THE GEORGE HOTEL

REVISION P1

Response to Historic England Comments

March 2023

2.1 Initial Elevation Changes

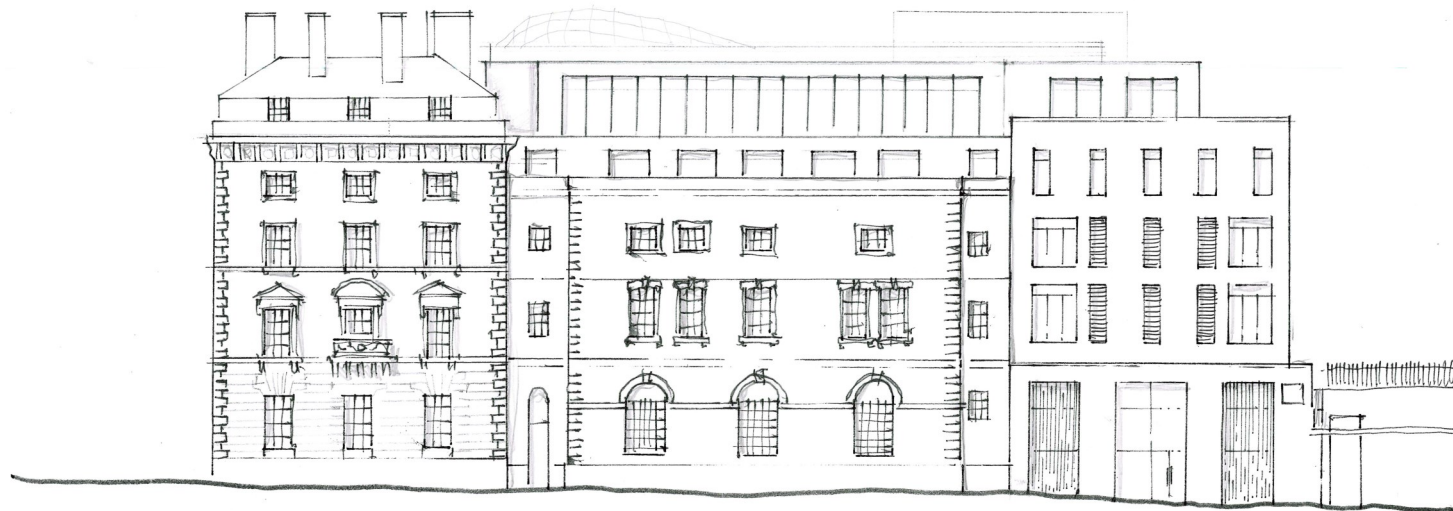
1. Query raised ref. elevational treatment to JWS new build.

- Should read separate to the retained section of façade
- Consider 'book-end' stone element at the apex to split the elevation into 3 distinct buildings.

2. Query raised ref. elevational treatment to car park side

- Stair core wall – should some variety/relief be proposed? Blind windows?
- If apex is amended as 3 above what happens as this element wraps around onto the CP elevation?

- Should top of stone new build section be lifted to align with the top of the stone parapet on block A?

3. Query raised ref. light weight upper storeys

- Can top floor be made less prominent generally?
- Should windows be reduced as per Victorian building?

Points addressed—see elevations opposite for number references:

- 1 Windows on new curved section of east elevation are mirrored as new blind reveals
- 2 Parapet increased on the west elevation and the parapet increase continues on the north to the east elevation

- 3 Level 04 glazing on west elevation lower panel concealed behind the parapet forming a better relationship with the existing mansard roof windows
- 4 Level 03 window types above the Block C façade on the east elevation have been regularised and spaced accordingly

- 5 Level 04 glazing on the east elevation up the end of the Block C façade has been conjoined to appear as a single volume
- 6 New massing to the north simplified by reducing the secondary material and extending the stone façade in the same plane up the new parapet height

- 7 Level 04 glazing on east elevation to the north above the new stone parapet matches item 3
- 8 Level 03 window types within the massing to the north are regularised and arranged uniformly across the east and west elevation

- 9 Level 01 & 02 windows types sitting in stone façade changed to match and arranged to form a sense of symmetry on the John William Street and echoed on each side to form a feature where the building façade converges

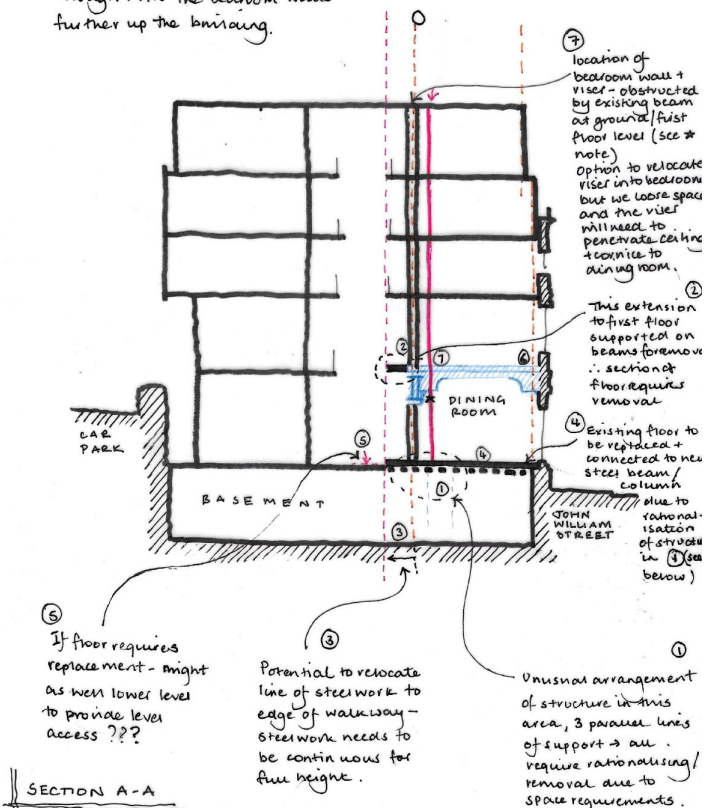
4. Re. Block C façade retention

Further justification required why block C 1930's restaurant @ ground floor cannot be retained.

★ 2 no large beams supporting existing first floor. These are on the line of the existing wall @ ground floor to the north + south.

These beams are clashing with the proposed locations of the columns + beams on grid line A which lines through into the bedroom walls further up the building.

⑥ ceiling to dining room to be altered to accommodate new steelwork supporting facade - steelwork needs to be continuous
